Project	<b>IEEE 802.16 Broadband Wireless Access Working Group</b> < <a href="http://ieee802.org/16">http://ieee802.org/16</a> >	
Title	<b>Clarification on uplink MIMO for relay station with multiple antennas</b>	
Date Submitted	<b>2007-09-16</b>	
Source(s)	<p>Anxin Li, Xiangming Li, Hidetoshi Kayama, Daqing Gu DoCoMo Beijing Labs Haidian District, Beijing, 100080, China</p> <p>Ismail Guvenc, Moo Ryong Jeong, Chia-Chin Chong, Fujio Watanabe DoCoMo USA Labs 3240 Hillview Avenue, Palo Alto, CA</p> <p>D. J. Shyy MITRE 7515 Colshire Drive McLean, VA 22102, USA</p> <p>Wen Tong Nortel 3500 Carling Avenue Ottawa, Ontario K2H 8E9</p> <p>Junhong Hui, D.H. Ahn, Young-il Kim ETRI 161, Gajeong-Dong, Yuseong-Gu, Daejeon, 305-350, Korea</p> <p>Yuefeng Zhou NEC EUROPE</p> <p>Mike Hart UKBroadband</p>	<p>Voice: +8610-82861501 E-mail: {liax,lixm,kayama,gu}@docomolabs-beijing.com.cn</p> <p>Voice: 650-496-4726 E-mail: {iguvenc, Jeong, cchong, watanabe}@docomolabs-usa.com</p> <p>E-mail: djshyy@mitre.org</p> <p>Voice: +613-763-1315 E-mail: wentong@nortel.com</p> <p>Voice: 82-42-860-6496 E-mail: {junhonghui, dhahn, yikim}@etri.re.kr</p> <p>E-mail: Yuefeng.Zhou@ttd.necur.com</p>

Re:	Call for Reply Comme

Figure 306a Mapping of data subcarriers for 3-antenna RS

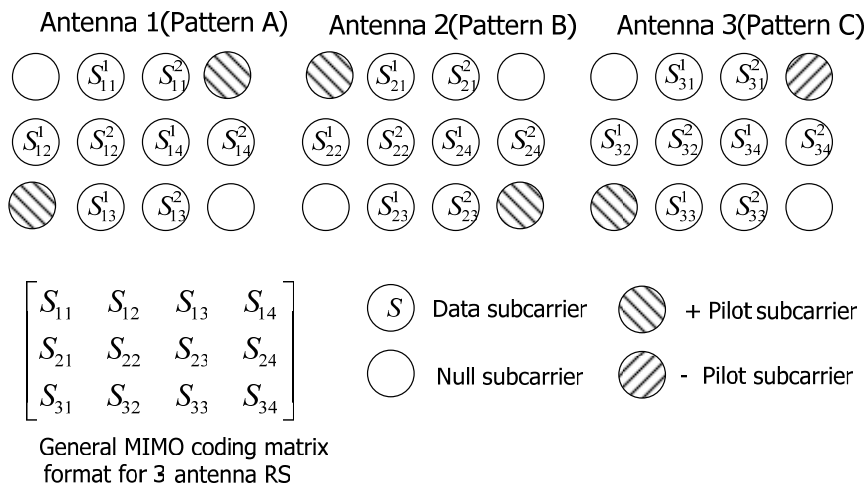
In IEEE 802.16 working group letter ballot #28, some comments point out that the superscripts in figure 306a and 306b are not clearly defined [1][2] and the meaning of the pilot subcarrier are ambiguous [3]. In this contribution, the meanings of the superscripts are clarified and in order to avoid the ambiguous meaning of the pilot subcarrier, the “pilot subcarrier” and “+ pilot subcarrier” are incorporated as “+ pilot subcarrier” in figure 306a and 306b because they have the same meaning.

For RS using three antennas, the MIMO coding matrices defined in 8.4.8.3.4 shall be mapped to the tile according to Figure 306a. **One tile shall contain two MIMO coding matrices.**  $S_{mn}^1$  denotes the  $m^{\text{th}}$  row  $n^{\text{th}}$  column element of the first MIMO coding matrix and  $S_{mn}^2$  denotes the  $m^{\text{th}}$  row  $n^{\text{th}}$  column element of the second MIMO coding matrix in the Figure 306a.
